AMENDMENT OF SOLICITATION/MODIFICATION OF CONTRACT			1. CONTRACT ID CODE		1	4
2. AMENDMENT/MODIFICATION NO. <div style="text-align: center;">2</div>		3. EFFECTIVE DATE 28-May-2004		4. REQUISITION/PURCHASE REQ. NO.		5. PROJECT NO. <i>(If applicable)</i>

Stilling Basin Wall Repair, Wilson Lake, Kansas

1. SOLICITATION NO. W912DQ-04-B-0005 is amended as follows:

Wilson Lake - Piezometers at Stilling Basin

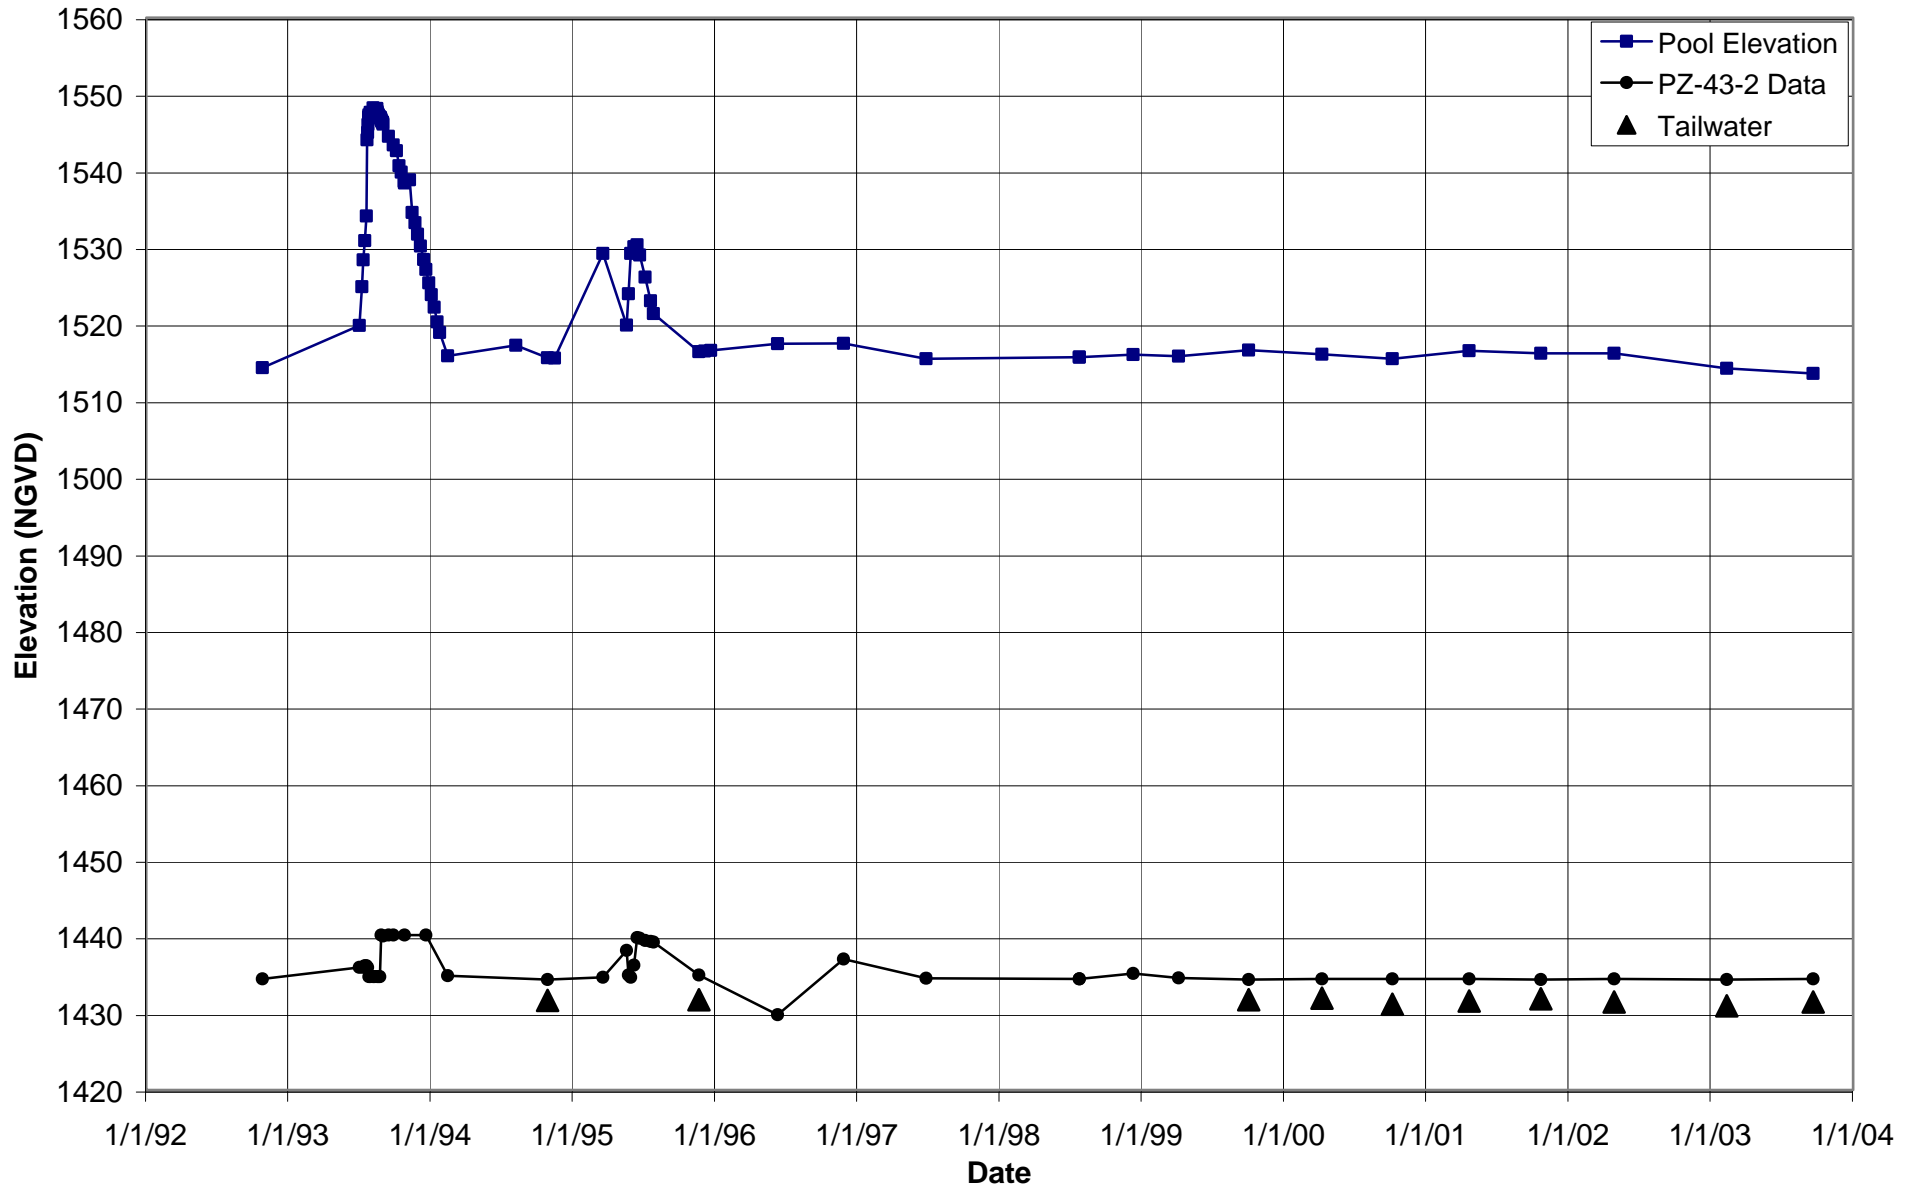
Historical piezometric data for the two piezometers adjacent to the stilling basin and boring logs for the instrumentation adjacent to the stilling basin are provided at the end of this section.

(Plots of the piezometric data and the boring logs accompany Amendment 0002).”
